## Issue List

## 10-16-23 FREDDYS - PROVO, UT

IMG\_5367  
10/16/2023

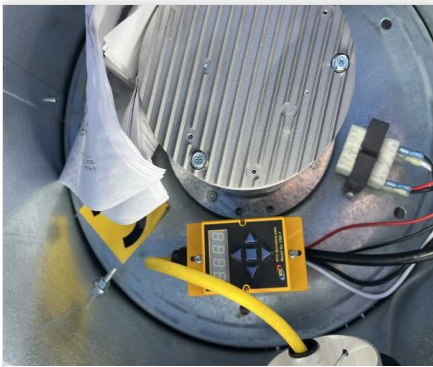
**Issue Name :** KEF2 no hinge kit installed  
**Description :** KEF2 has no hinge kit installed to lean the fan back for cleaning. The hinge kit was installed on KEF3 for the dishhood fan where it is not needed. Recommend MC remove the hinge kit from KEF3 and put it on KEF2.  
**Created By :** National TAB                      **Assigned To :** National TAB - Jacob Davidson  
**Status :** Closed  
**Originated Date :** 10/16/2023 - Jacob Davidson - National TAB

- **10/17/2023 National TAB - Jacob Davidson**
  - Units had their hinge kits swapped over to correct curbs. Closing ticket
- **10/16/2023 National TAB - Jacob Davidson**
  - Added photos
